RAMP REPORT REGION 2 ADA 2026

Lawerence St., & Ingraham Lane,
Rockland

CR16764

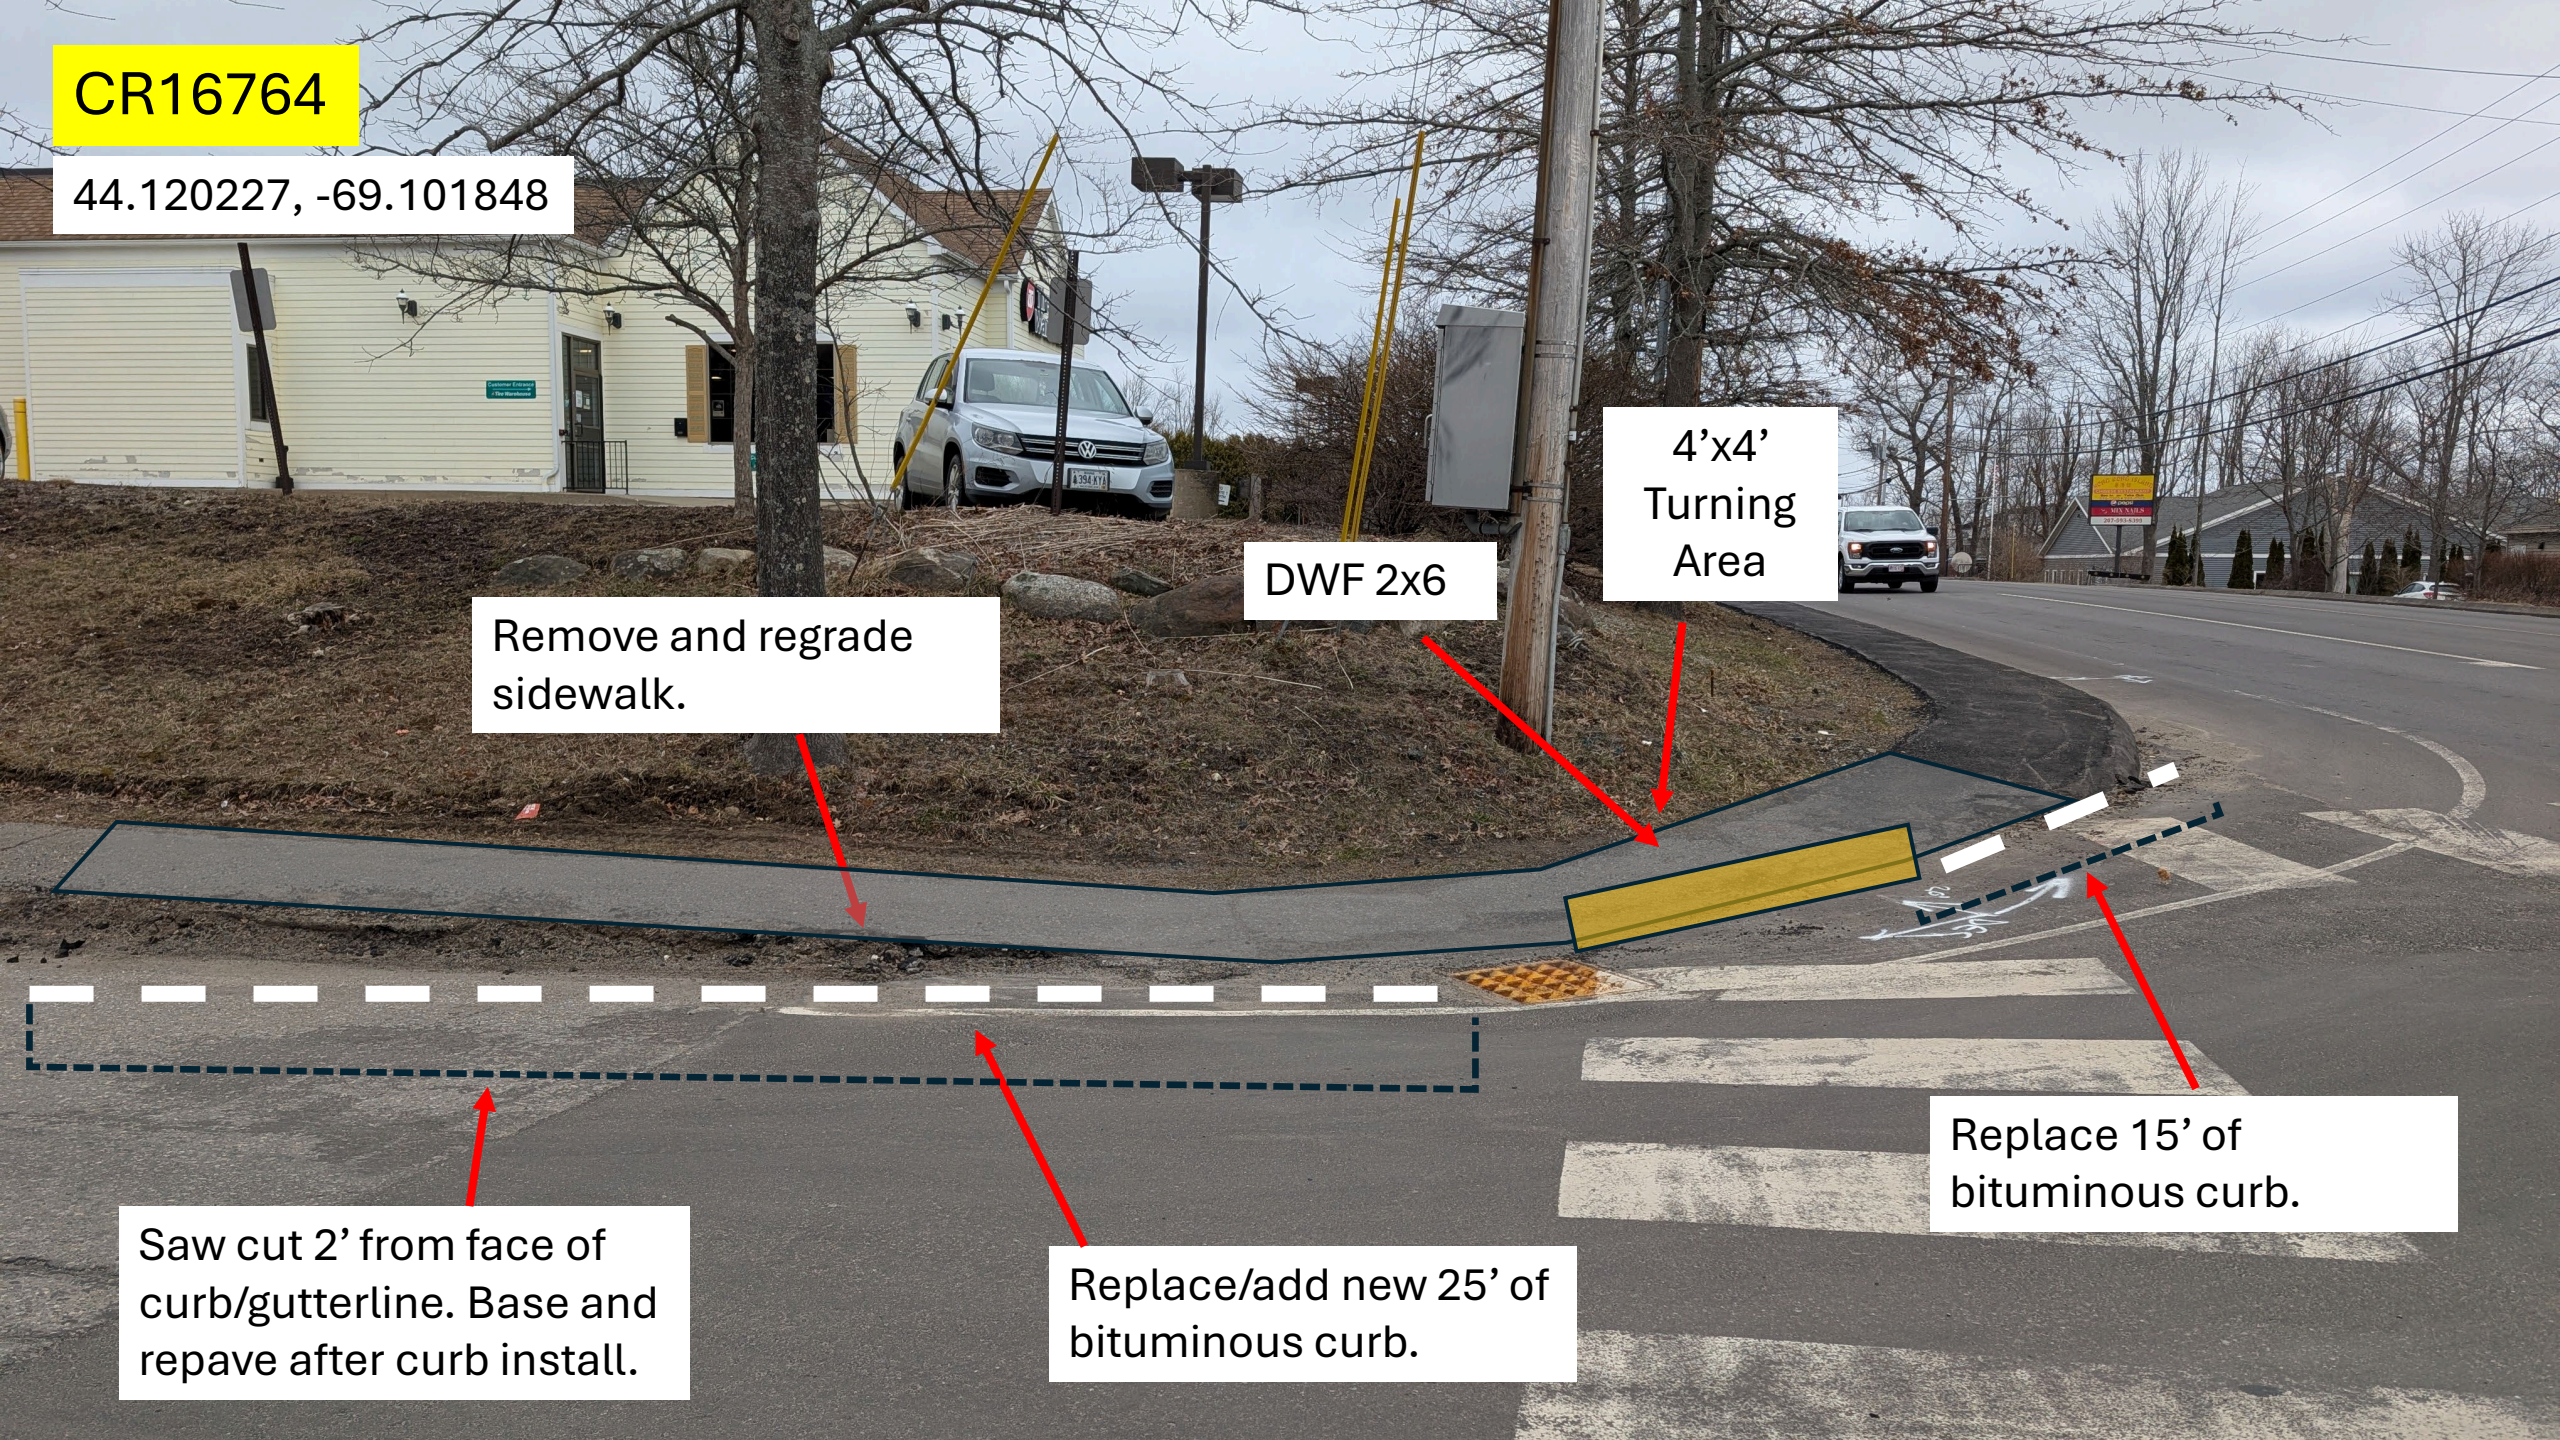
Remove and regrade
sidewalk.

DWF 2x6

4'x4'
Turning
Area

Replace 15' of
bituminous curb.

Saw cut 2' from face of
curb/gutterline. Base and
repave after curb install.

Replace/add new 25' of
bituminous curb.

CR16765

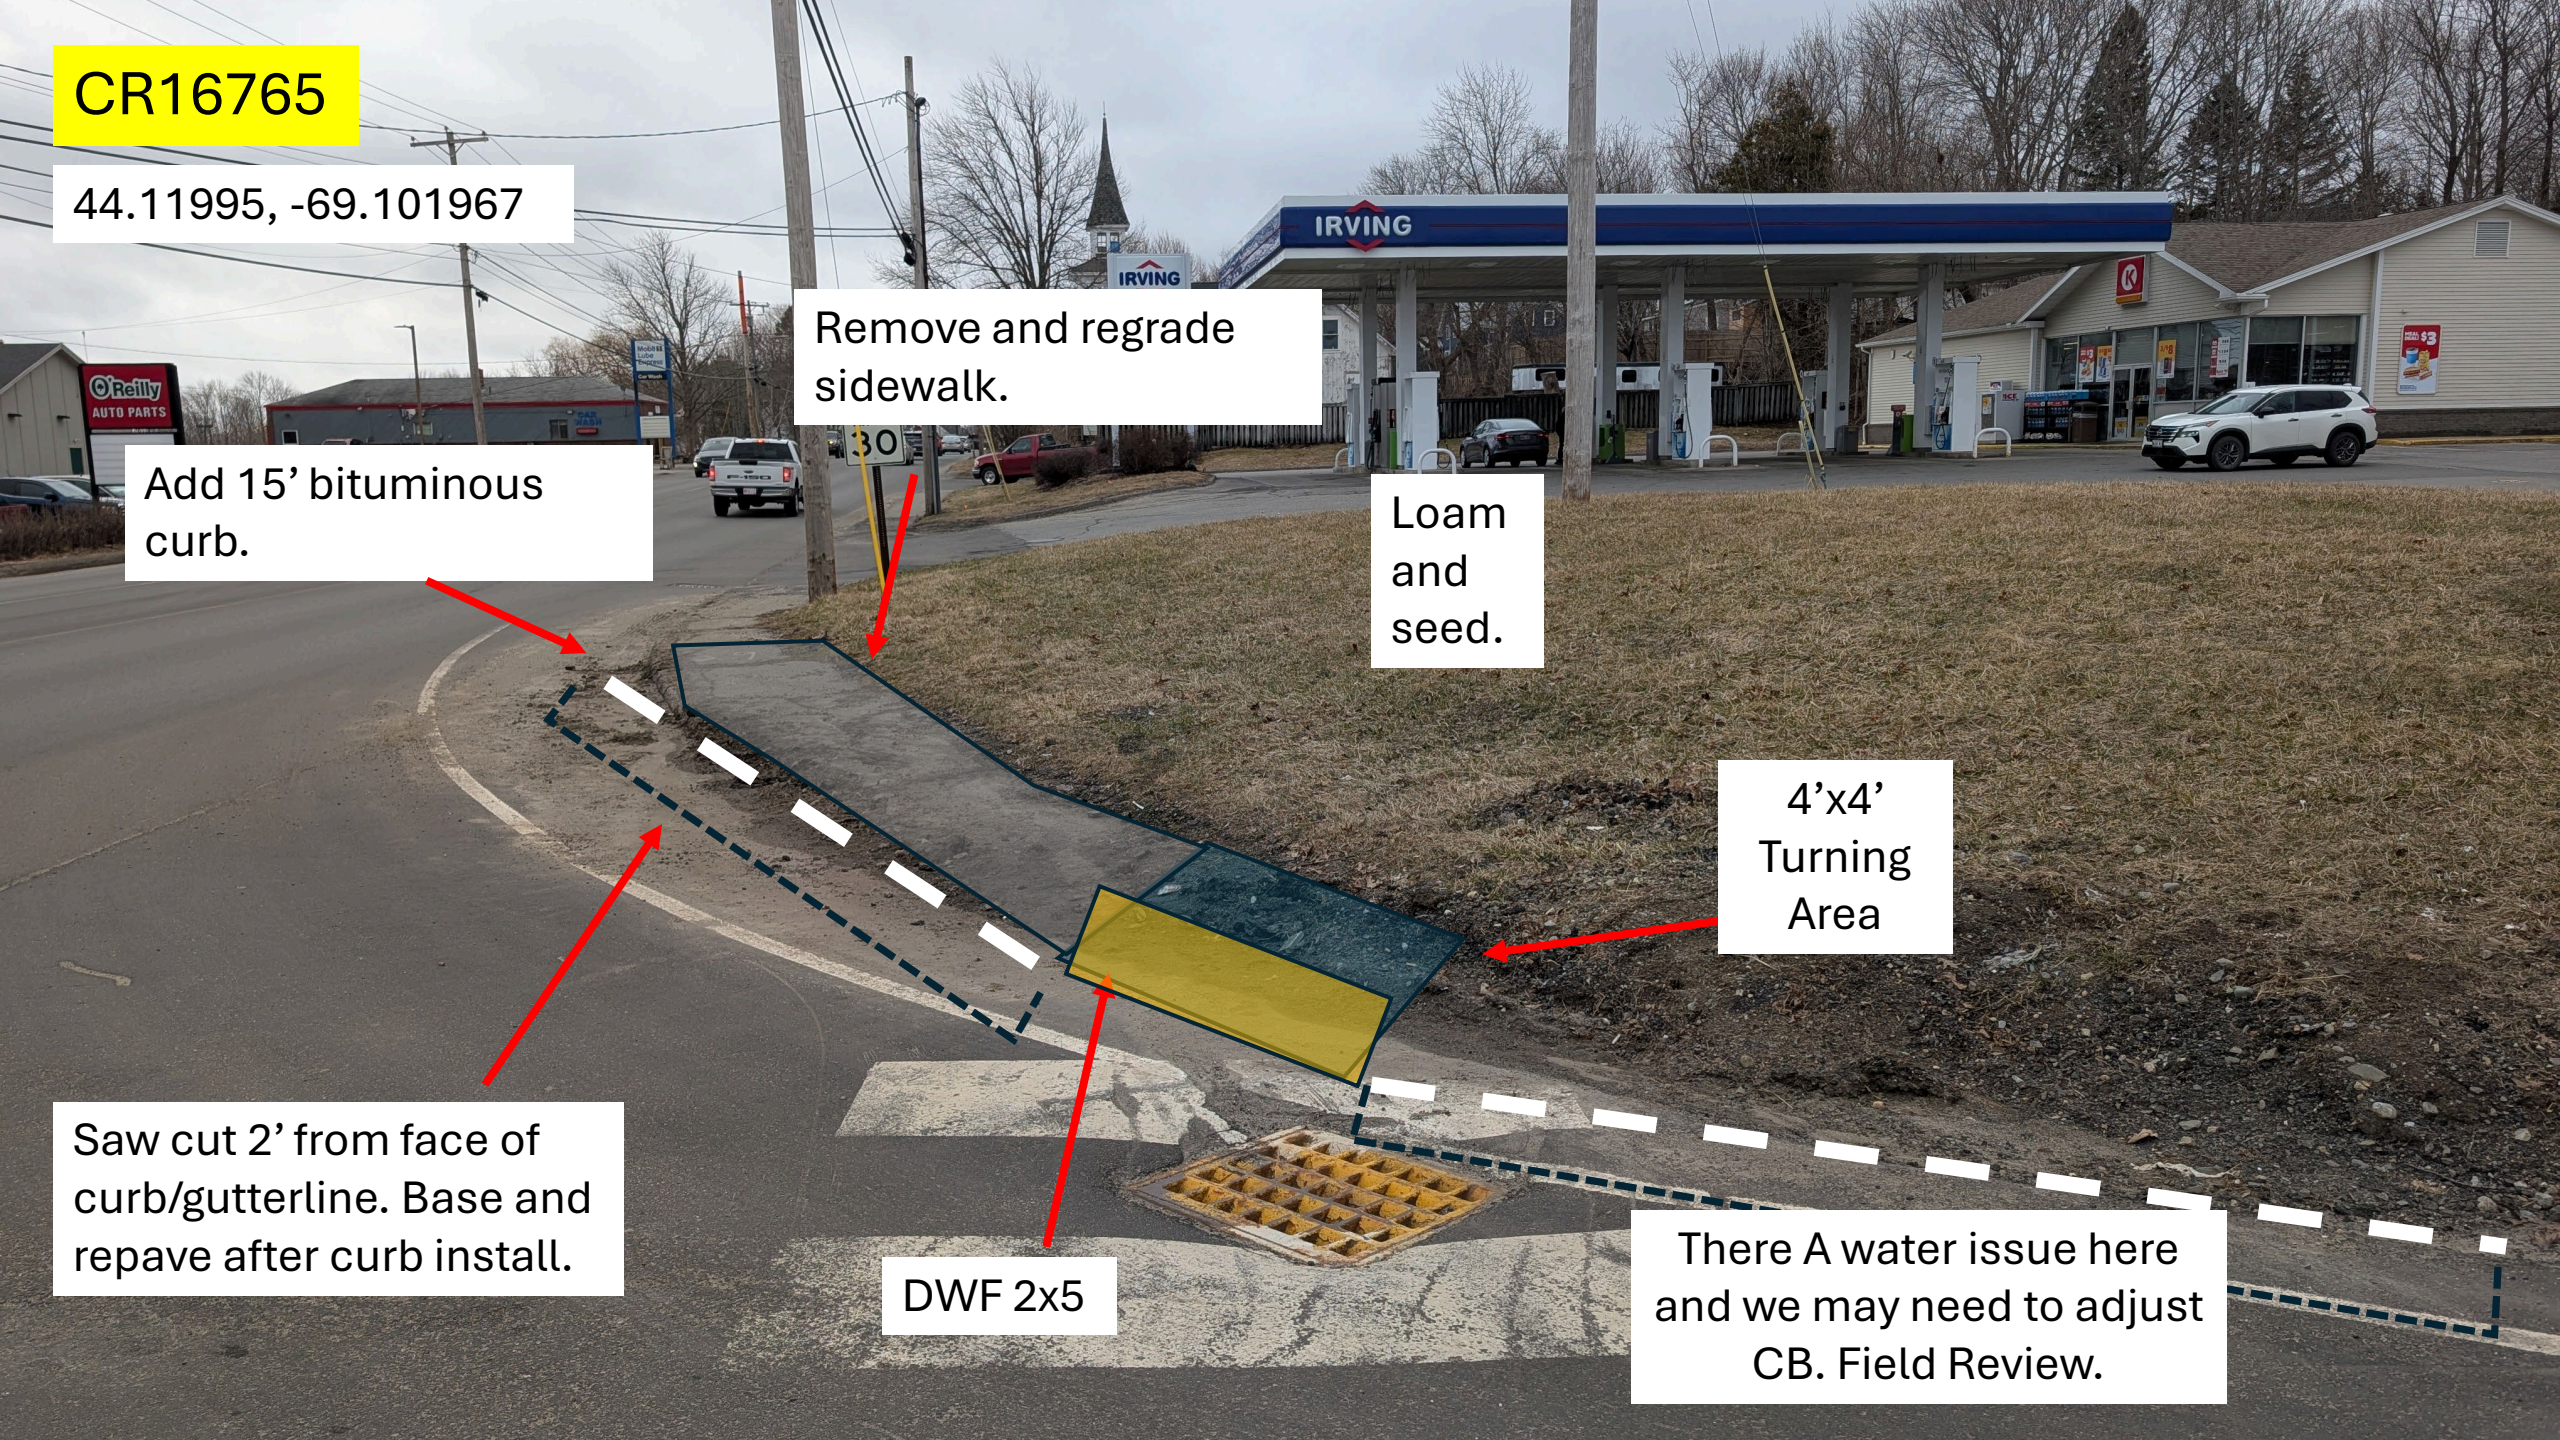
Add 15' bituminous curb.

Remove and regrade sidewalk.

Loam and seed.

4'x4' Turning Area

Saw cut 2' from face of curb/gutterline. Base and repave after curb install.

DWF 2x5

There A water issue here and we may need to adjust CB. Field Review.

CR16762

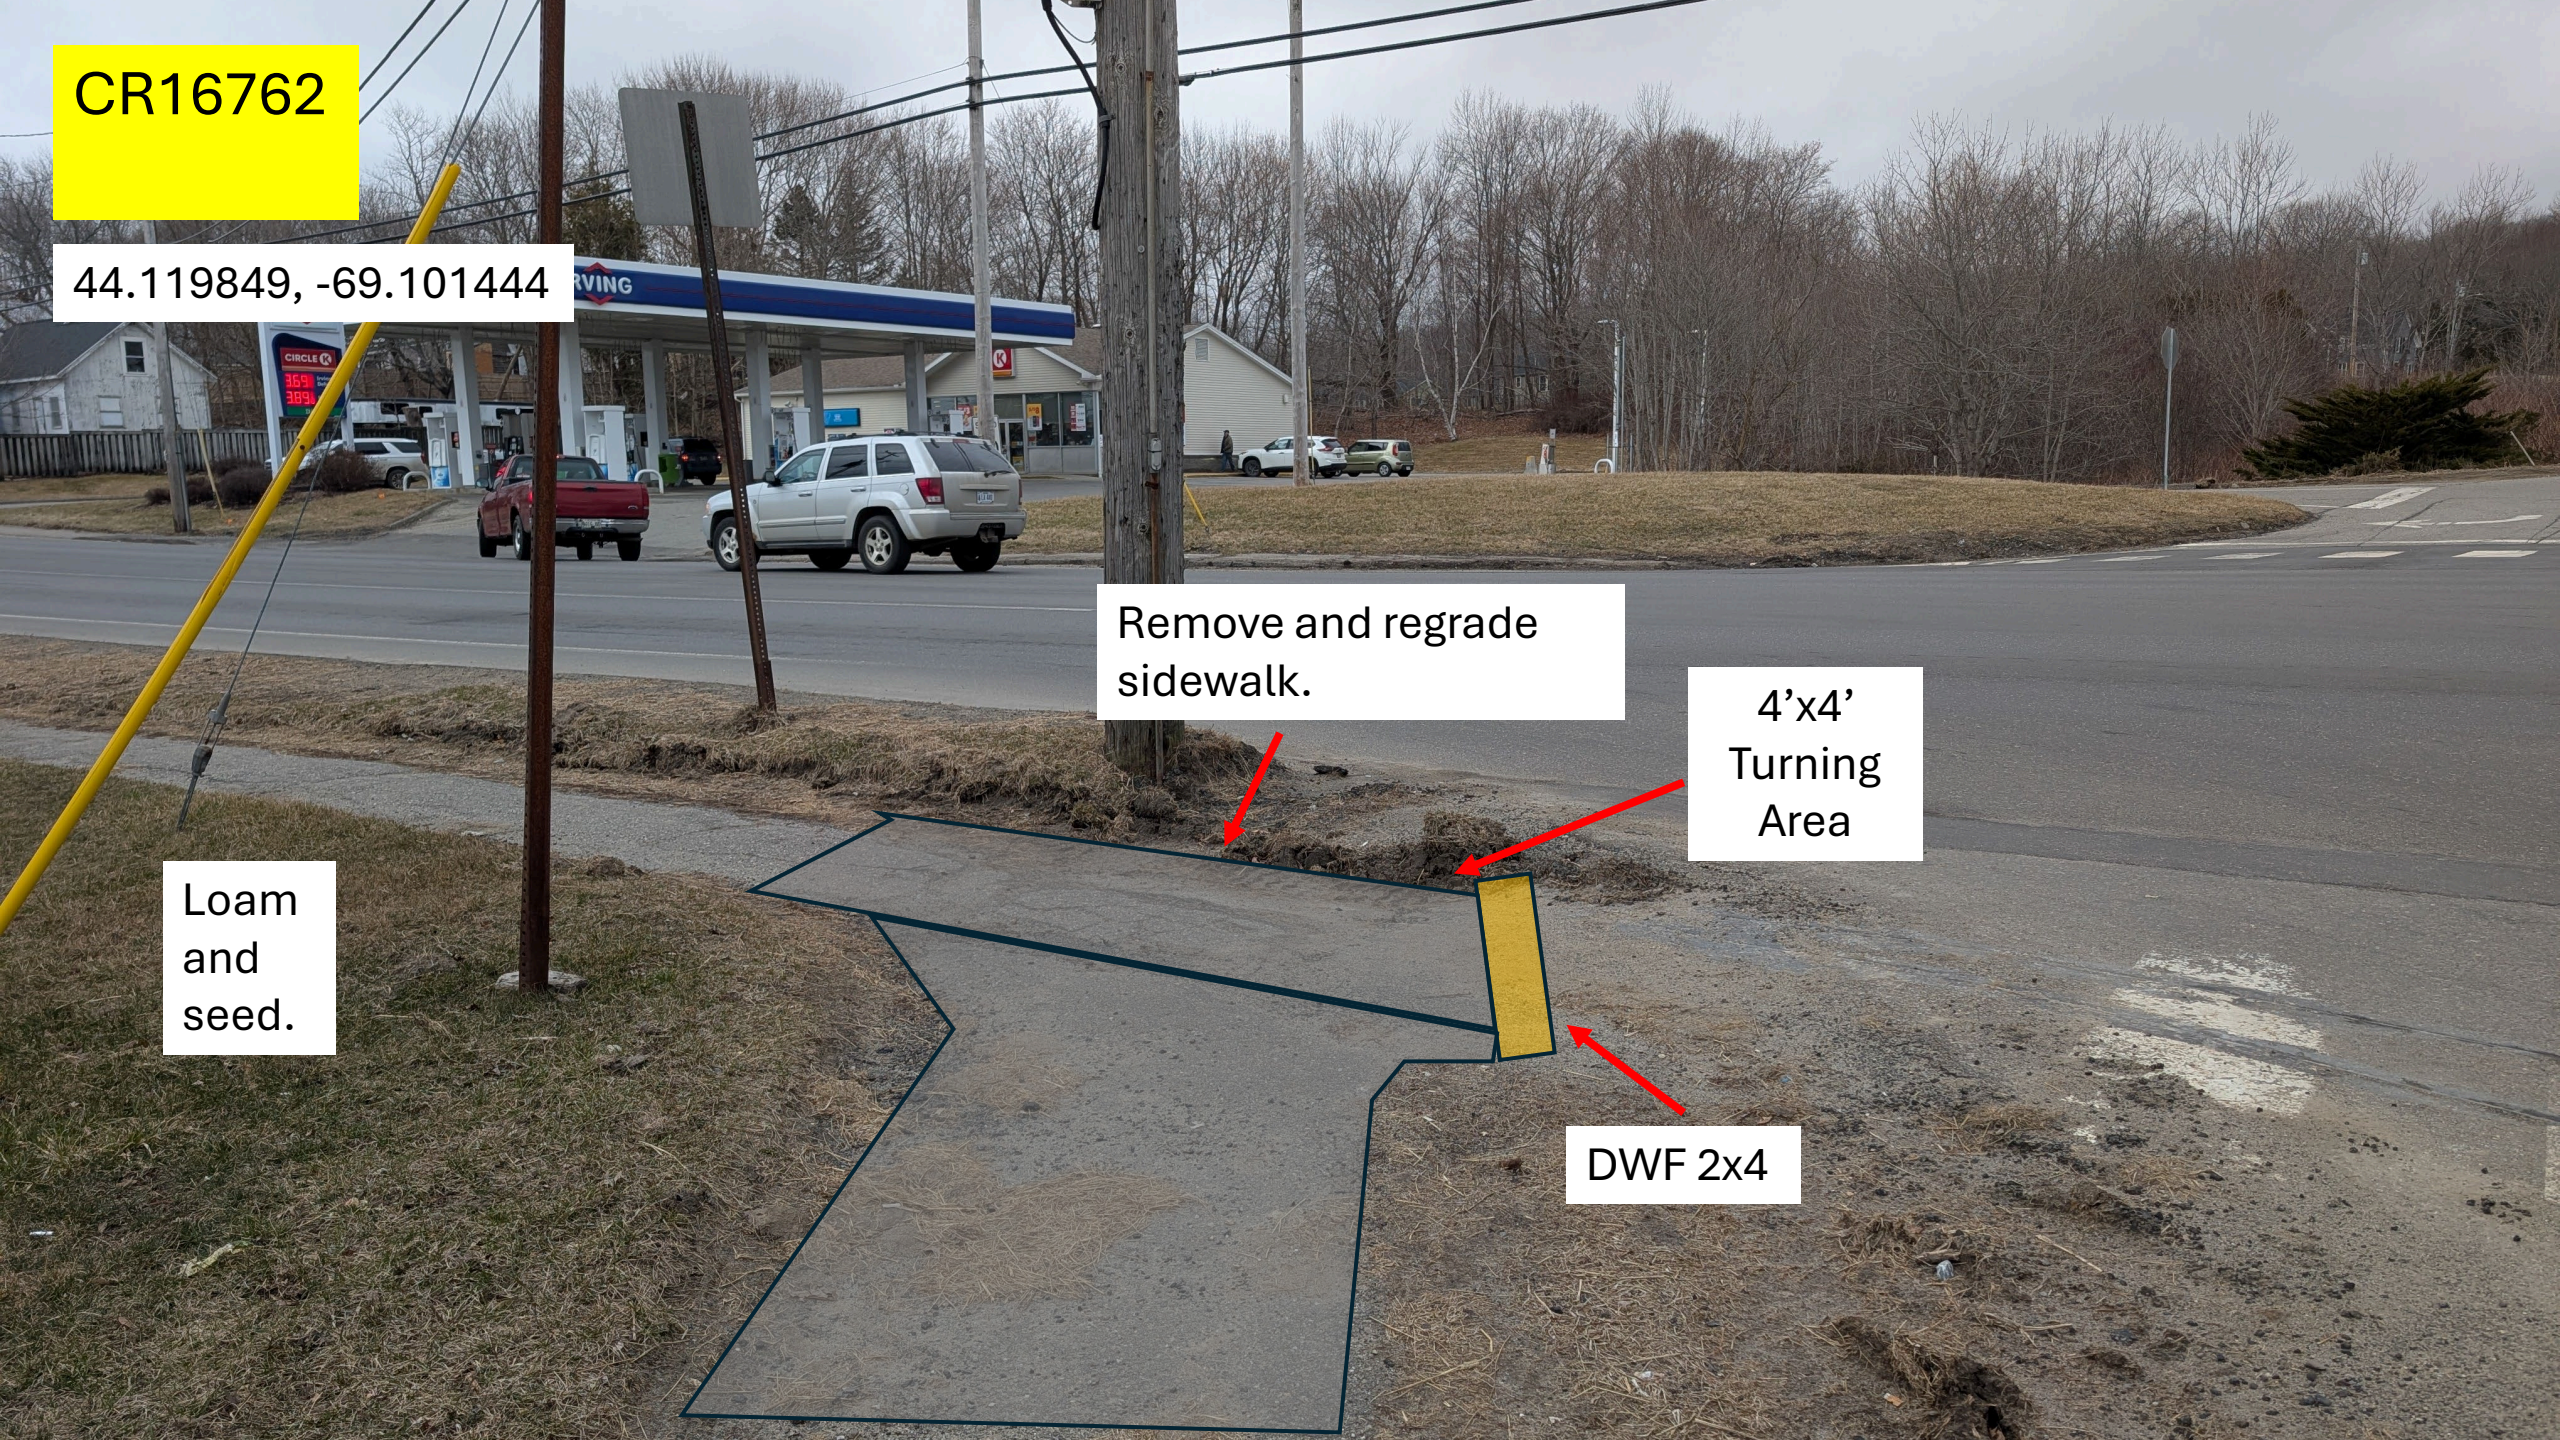
Loam
and
seed.

Remove and regrade
sidewalk.

4'x4'
Turning
Area

DWF 2x4
